FINAL PLAT
ELLSON COURT ADDITION
AN ADDITION TO WICHITA, SEDGWICK COUNTY, KANSAS

RE: SUB 2000-56 -- One-Step Final Plat of ELLSON COURT ADDITION

CASE NUMBER: SUB 2000-56 -- ELLSON COURT ADDITION

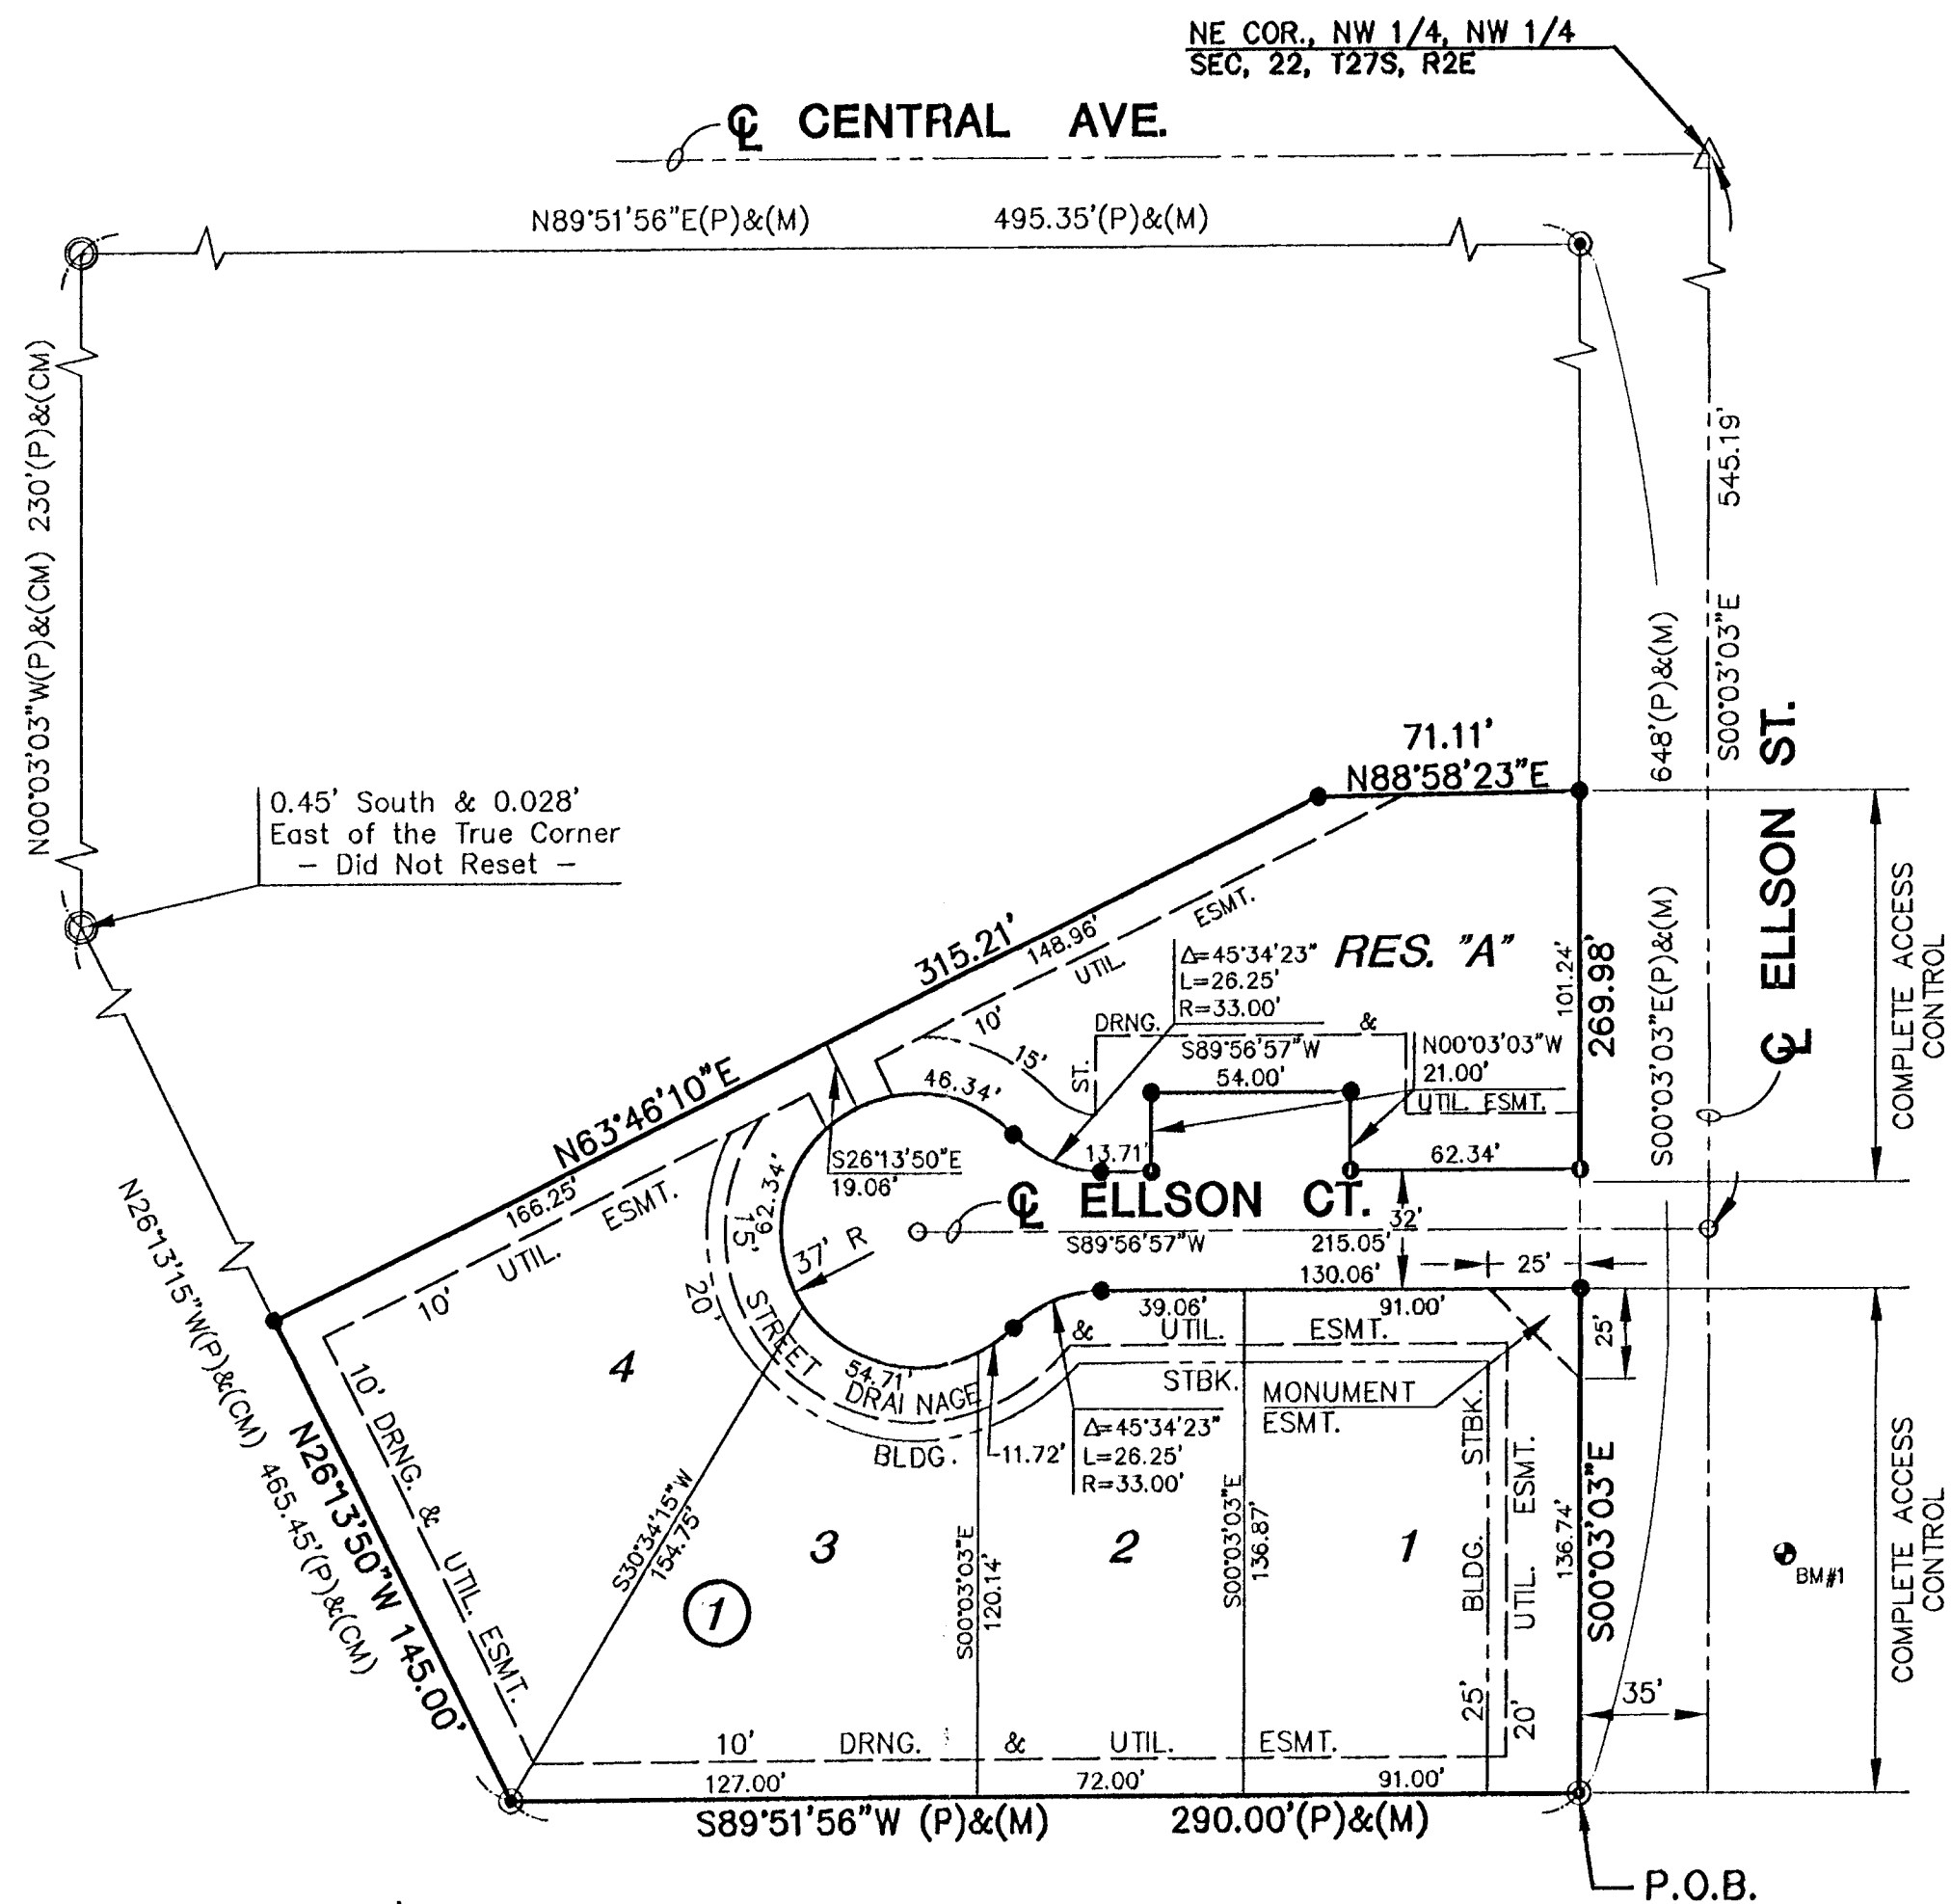
- E. City Engineering needs to comment on the status of the applicant's drainage plan. The drainage plan is approved.
- F. A minimum pad elevation as shown on New Life Christian Church Addition of 1366.4 MSL (179 City Datum) needs to be added.

- G. A benchmark needs to be added.

- I. The dimension on the east line of Lot 5, Block 1, needs to be changed from 230.94' to 155.72'.
- J. Provisions shall be made for ownership and maintenance of the proposed reserves. The applicant shall either form a lot owners' association prior to recording the plat or shall submit a covenant stating when the association will be formed, when the reserves will be deeded to the association and who is to own and maintain the reserves prior to the association taking over those responsibilities. The applicant will eliminate Reserve B from the final tracing.

- M. The applicant shall guarantee the paving of the proposed interior street.
- N. Access control except one opening" should be deleted and replaced by complete access control being platted for the plat's frontage along Ellson.

- O. The building setback line should be denoted by a dashed line.
- P. Traffic Engineering shall comment on the parking easement for back-out parking that is platted within a street curve. The Subdivision Regulations require parking easements to be a minimum of 20 feet deep and have a maximum street frontage of 50 feet. The perimeter of the parking easements shall be redrawn to comply with these requirements. The applicant has agreed to revise the parking easement dimensions.

- DD. A sewer easement needs to be platted through Lot 5 and Reserve A to cover an existing sewer line.

- G. A benchmark needs to be added.
- H. The 15-ft utility easement adjacent to Ellson Court should be redesignated as a Street Drainage and Utility Easement.

- I. The dimension on the east line of Lot 5, Block 1, needs to be changed from 230.94' to 155.72'.
- J. Provisions shall be made for ownership and maintenance of the proposed reserves. The applicant shall either form a lot owners' association prior to recording the plat or shall submit a covenant stating when the association will be formed, when the reserves will be deeded to the association and who is to own and maintain the reserves prior to the association taking over those responsibilities. The Applicant will eliminate Reserve B from the final tracing.
